# AFFORDABLE ELECTRICITY FOR KOSOVO?

A Review of World Bank Group Cost Estimates  
For New Lignite-fired Plants in Kosovo

Bruce C. Buckheit  
October, 2011

Prepared for:  
The Sierra Club  
The Kosovar Institute for Policy Research and Development

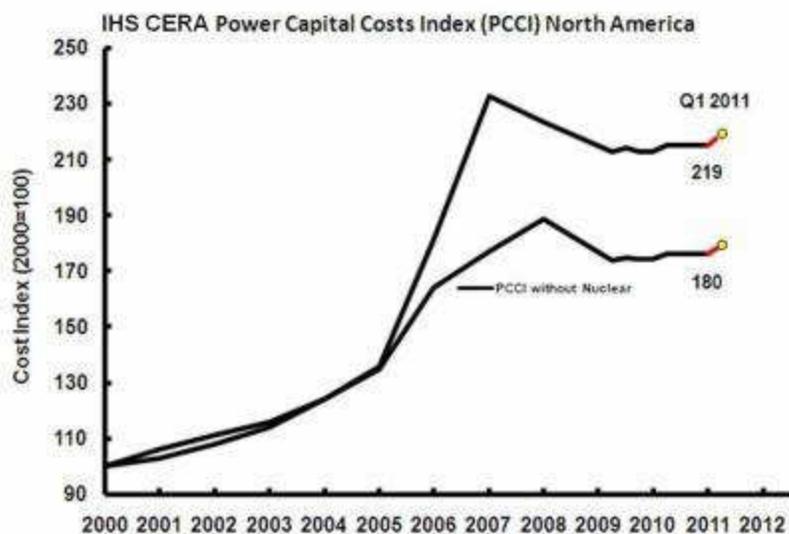
The LCOE estimate in the TOR assumes that the capital investment for the new facility would be 1000 €/kW (\$1,360/kW) of capacity or €660 million (\$897 million<sup>10</sup>) for the two new units if they are subcritical designs, and 1100 €/kW for SCPC<sup>11</sup>. This is far lower than the International Energy Agency (“IEA”) overnight capital cost estimate of \$2,762/kW for brown coal fired generation in the Slovak Republic, \$3,486/kW for the Czech Republic or \$2,197/kW in Germany. It is also substantially lower than the average figure published by the U.S. Department of Energy of \$2,408/kW. Finally, it is inconsistent with the most recent estimates prepared for this project. Construction costs have shown extreme volatility in the past few years. The IHS CERA Power Capital Cost Index<sup>12</sup> is one of a number of sources that document the sharp rise in capital cost of construction since the initial “Pre-Feasibility” estimates were prepared for Kosovo C.
